DFCM Addendum #1

Reference: MTECH Provo – Phase 5B - Practical Nursing
 DFCM Project #18207260
 U3P Event #CS26018

ADDENDUM NO. 1

**MTECH Provo Phase VB
Practical Nursing
DFCM Project #18207260**

A1 LEVEL 1 DIMENSION PLAN
1/8" = 1'-0"

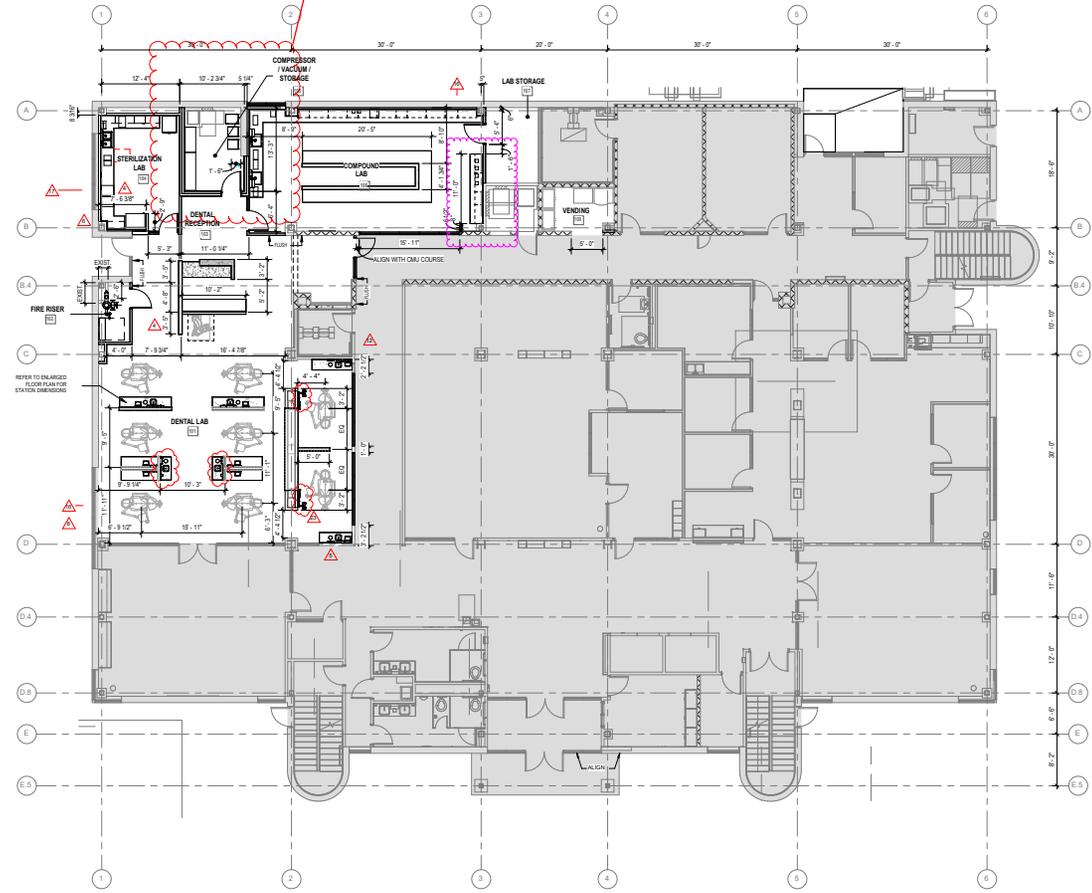
74. Question: PE103.1 note 6 says to tie into compressor on level one. Can a floor plan of level one be provided? Is an additional isolation valve being added in at level one so level one can be isolated from the other levels. **Response: See response provided by WHW Engineering.**

COMPRESSOR LOCATION

LEVEL 1 EQUIPMENT
WRAP

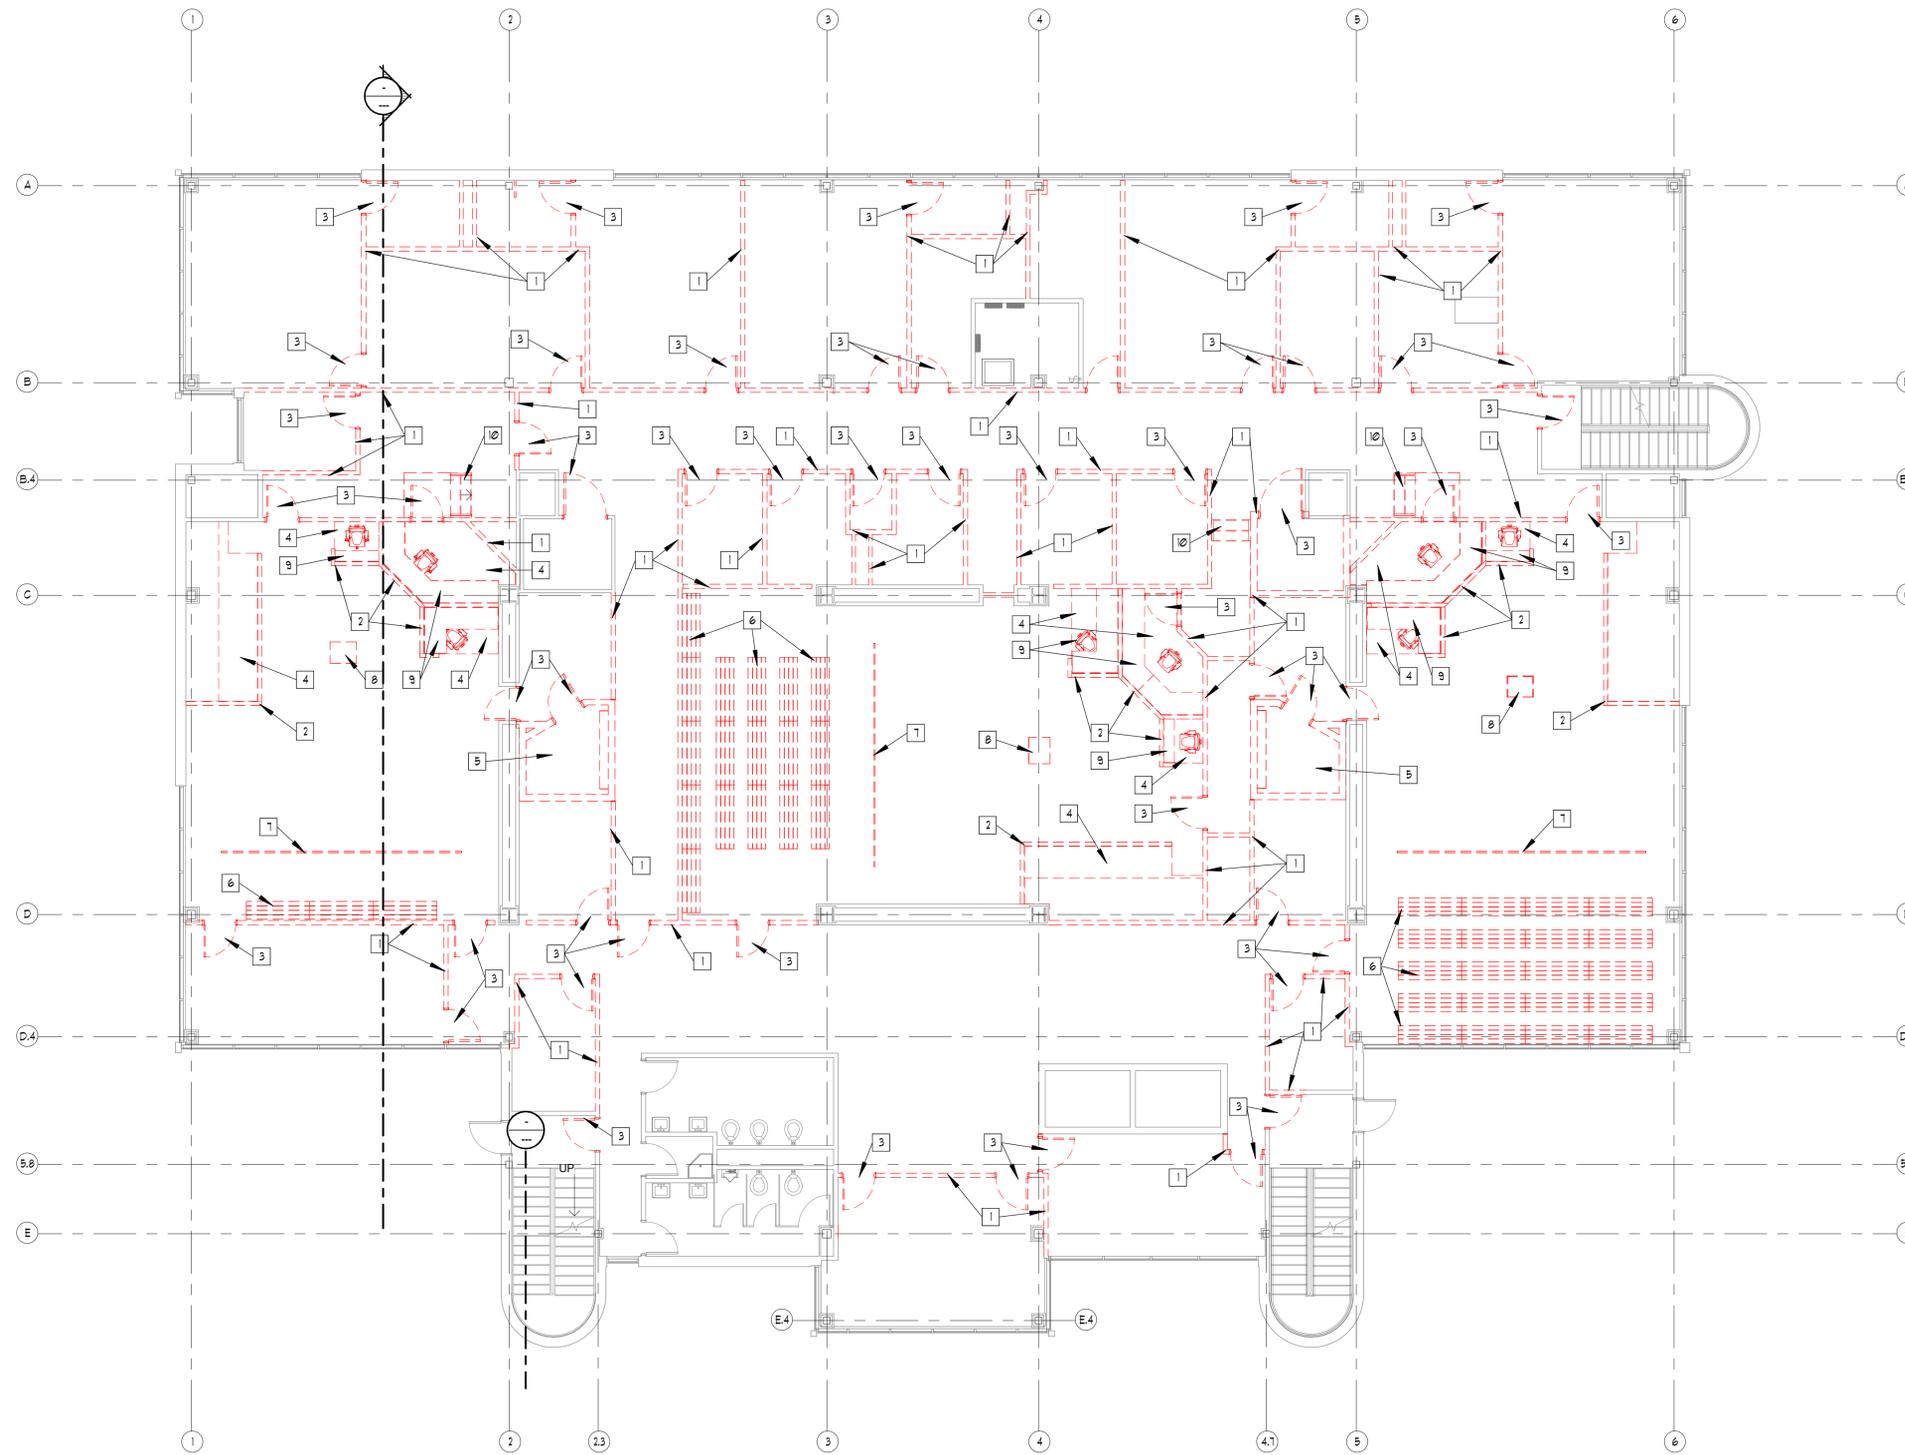
60. Question: A1.0 Please clarify the "wrap" called out. It notes ¾" plywood and 2x4 framing turned flat. Is this meant to be a millwork encasing of the lockers for esthetic purposes? Are we just leaving exposed plywood? Is the plywood a veneer stain grade? Etc. **Response: The framed shell around the lockers shall consist of 2x4 framing (placed sideways) and plywood sheathing. For aesthetic purposes, stain-grade veneer shall be applied to the surface of the plywood at both ends of the lockers. 1x wood trim shall be provided around the front of the lockers to conceal the millwork assembly Notes and details on sheet A1.0 have been updated to reflect such.**

3. Sheet A1.0: Sheet notes 3 & 7 updated, with note change on detail 3.
4. Sheet A2.0: Demolition sheet note 3 updated. Minor changes to made to "Demolition General Notes" (DGN) 1, 3, 4, & 5. DGN 6 eliminated and DGN 7, 8, 9, & 10 renumbered to 6, 7, 8, & 9, respectively. New DGN number 7 revised. DGN 11 & 12 eliminated.

LEVEL 3 DEMO PLAN

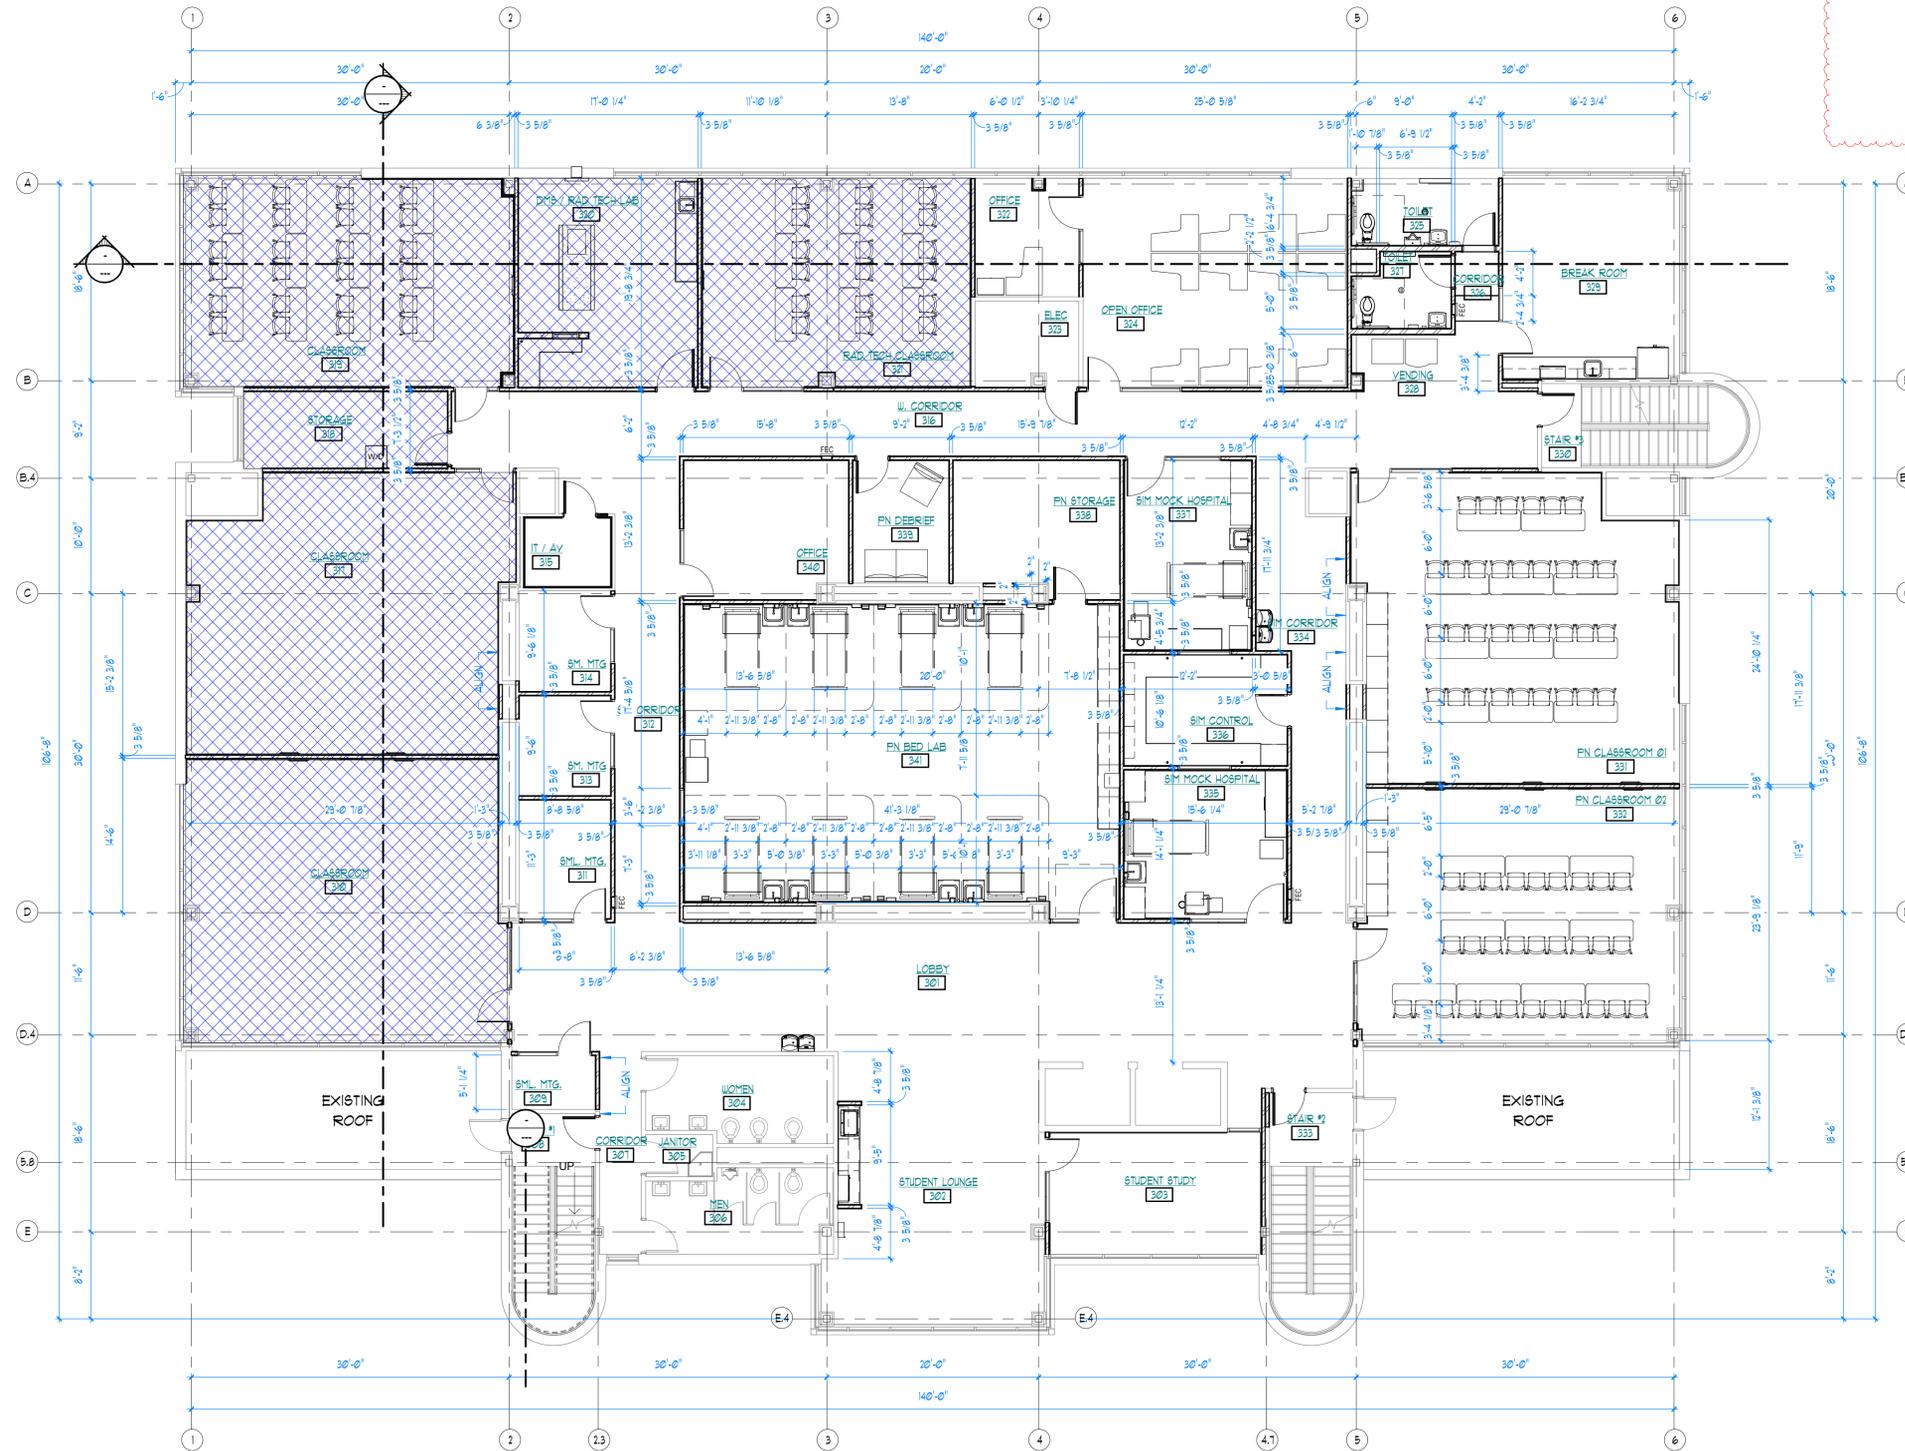
61. Question: A2.0 General demo note 6 says we are reusing doors. Is this applicable to all doors and frames or just the three stair doors and frames? **Response: Doors will not be re-used. Demolition general note 6 has been removed.**

62. Question: A2.0 General demo note 8 says to salvage all light fixtures, clean and repair to functioning condition. Similar situation for the mechanical grilles, exhaust fans. There is NO WAY to bid this competitively, everyone will look at what is needed differently. Please review and advise. Response: Light fixtures will not be re-used. Contractor shall remove them and the owner shall coordinate with a hazmat team to inspect and dispose of the removed bulbs and ballasts. General note 8 has been updated. Note that it is now note 7 due to the deletion of what was previously general note 6.

63. Question: A2.0 General demo note 12 says to save doors for hazmat testing. Dispose only if found to be free of hazardous content. Can this testing and disposal be done before this project starts? Any remaining doors would simply be disposed of except for the three stair doors called to be reused? Response: Hazmat testing has already been completed. All doors indicated to be removed can be disposed of. General demolition note 12 is not necessary and has been deleted.

7. REMOVE EXISTING LIGHT FIXTURES AS INDICATED ON THE REFLECTED CEILING DEMOLITION PLAN (SHEET A8.1). REMOVE BULBS AND BALLASTS FROM EACH LIGHT FIXTURE FOR OWNER DISPOSAL. DISPOSE OF REMAINING COMPONENTS FROM EVERY LIGHT FIXTURE REMOVED.

LEVEL 3 DIMENSION
PLAN

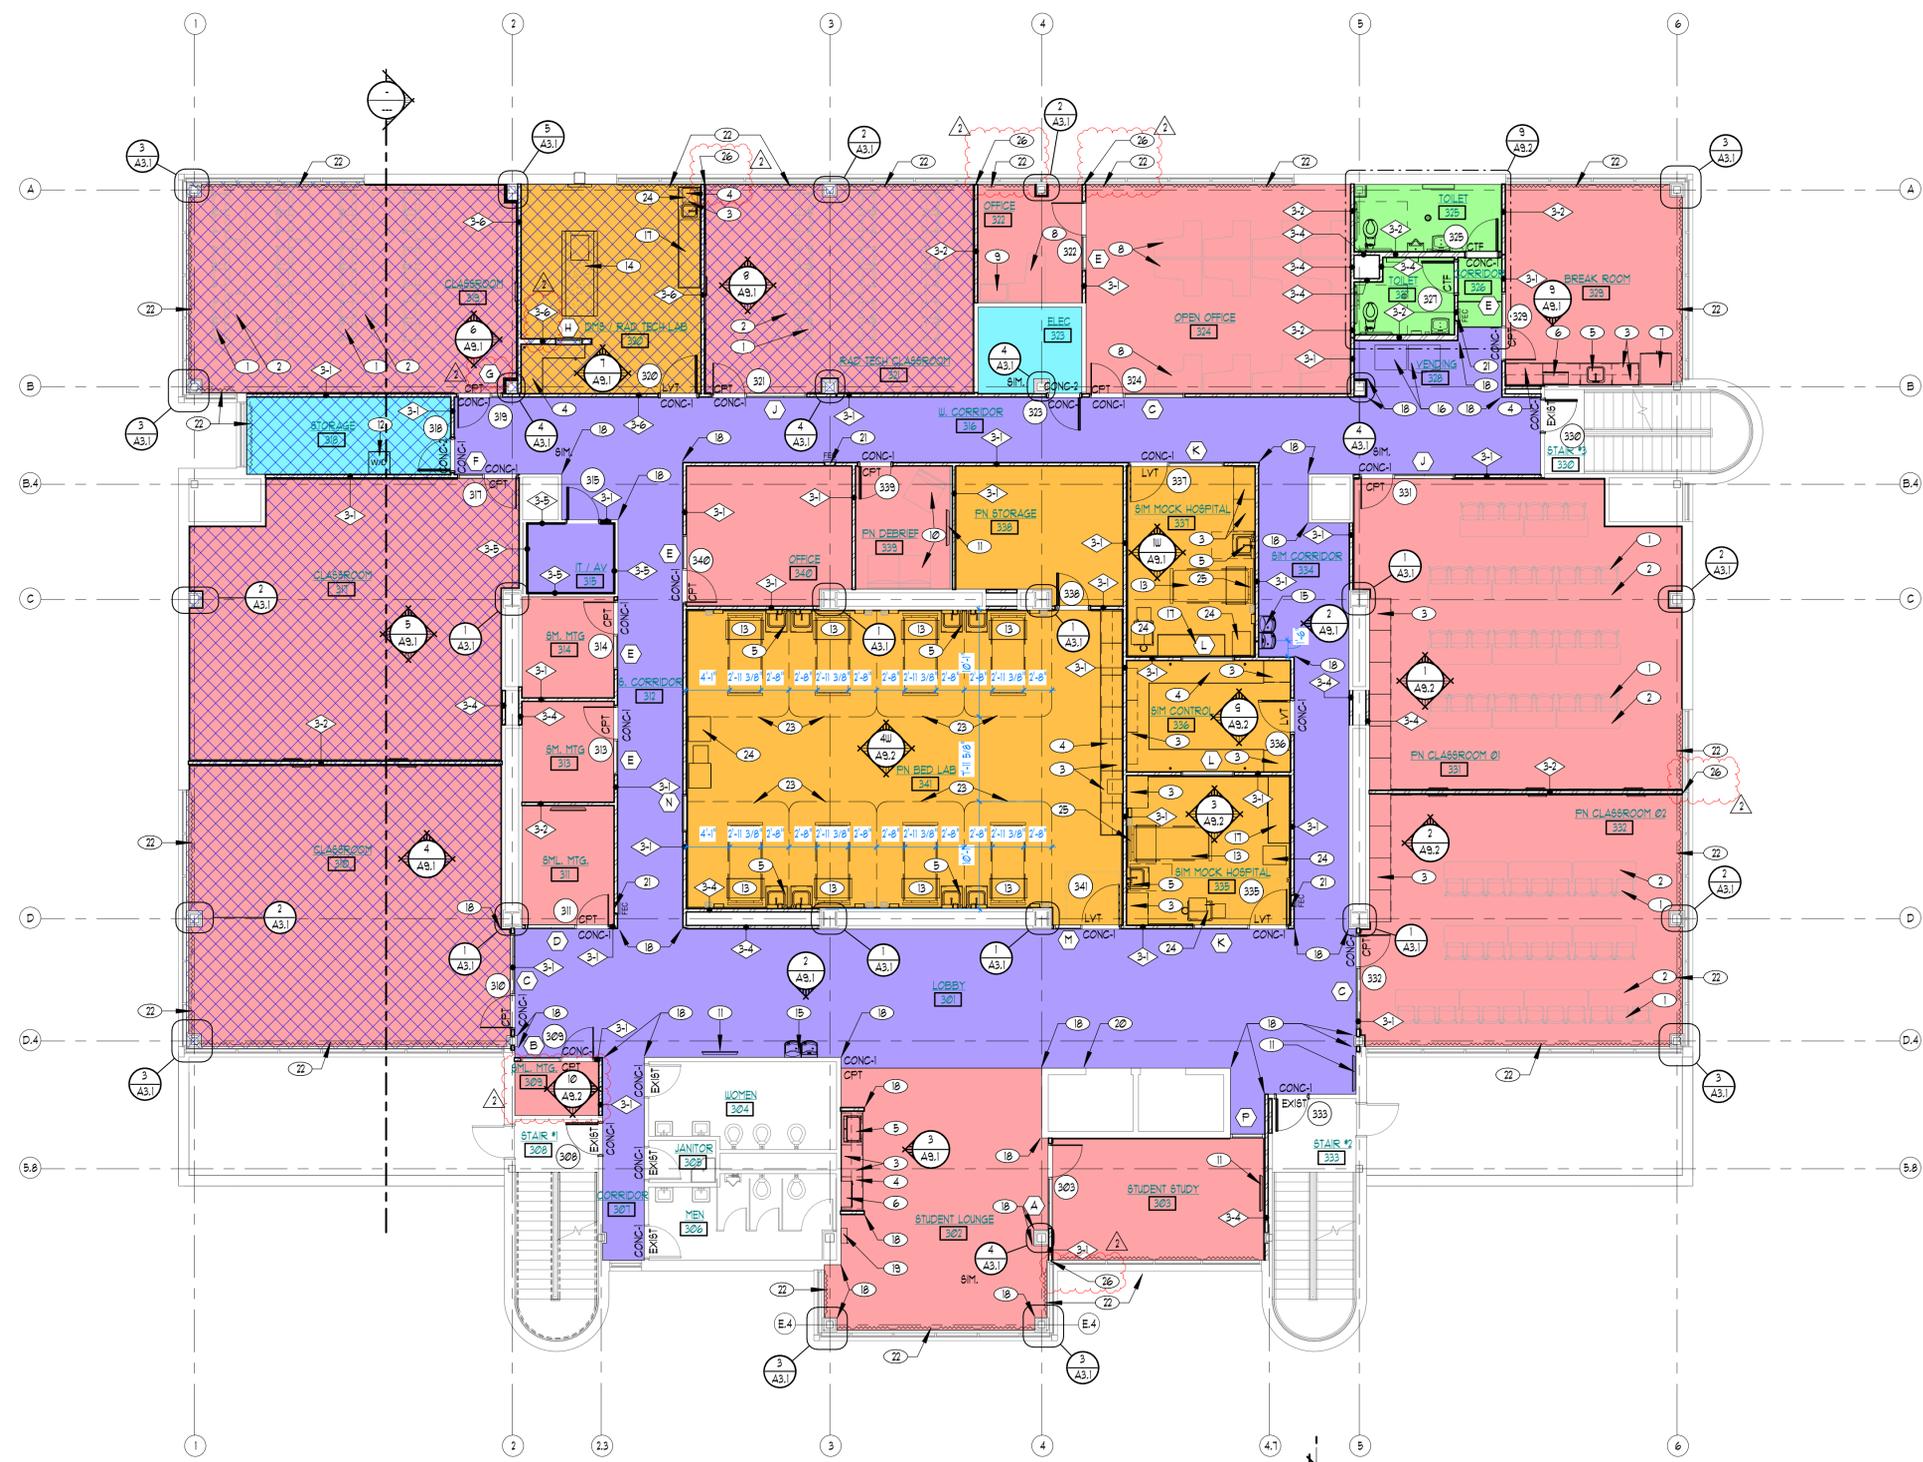
64. Question: A2.1 alternate scope definition. Are the "Hallway walls" for the blue hatched area supposed to be installed and finishes complete on the hallway side? What about doors/frames, that swing in? Are all the doors and frames in those walls to be included in the base bid? Response: The hatch is located inside of the walls. Construction of the walls and associated doors / frames are to be included in the base bid. Alternate description on sheet G1.1 has been updated and note has been removed from A2.1 for consistency.

5. Sheet A2.1: Bid Alternate Notes removed. See sheet G1.1 for notes.
6. Sheet A2.2: Updates to sheet notes indicated. Bid Alternate notes removed. See sheet G1.1 for notes. Sheet note 26 added to plan. Window Type G added to plan at door 319. Interior elevation reference added to Small Meeting (309).
